1. Revised Conservation Agenda

Town of Franklin

TECHNICAL MEMORANDUM

SUBJECT: **Peer Review Comment SW21**
444 East Central Street, Franklin, MA

Rating Curve Plot for Crossing: Northern Spy Road

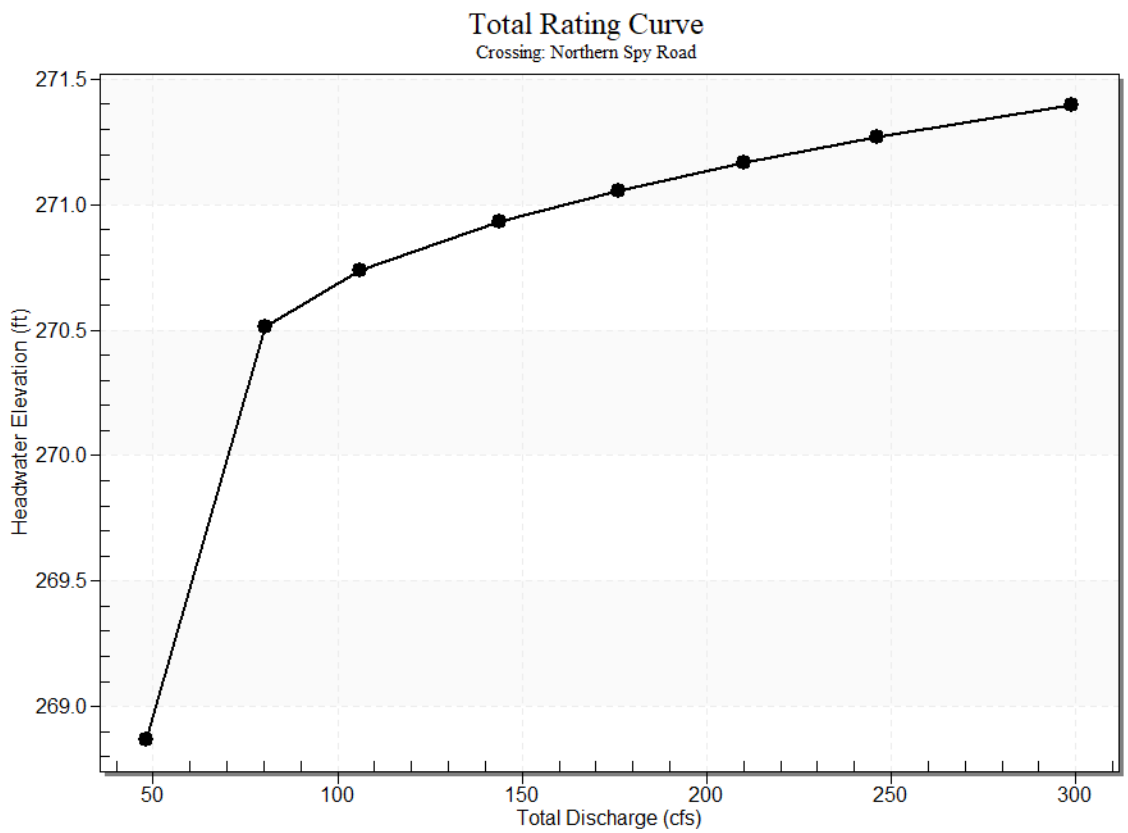
Comment SW21: *The HydroCAD model has been updated, and an HY-8 model has been provided to analyze the capacities for the existing culverts. HY-8 should also be used to model the proposed conditions to demonstrate there will be no adverse impacts to flood levels following construction.*

The Northern Spy Road culverts were not altered in the updated model. The original results from the analysis at that point remain for this updated analysis. As was previously noted, the results at Northern Spy Road indicate that the roadway overtops between the 2- and 5-year events with the water level continuing to rise throughout the various storms.

Northern Spy Road Analysis		
Storm Event (year)	Total Discharge (cfs)	Headwater Elevation (ft)
2	48	268.87
5	80.3	270.51
10	106	270.74
25	144	270.93
50	176	271.06
100	210	271.17
200	246	271.27
500	299	271.40
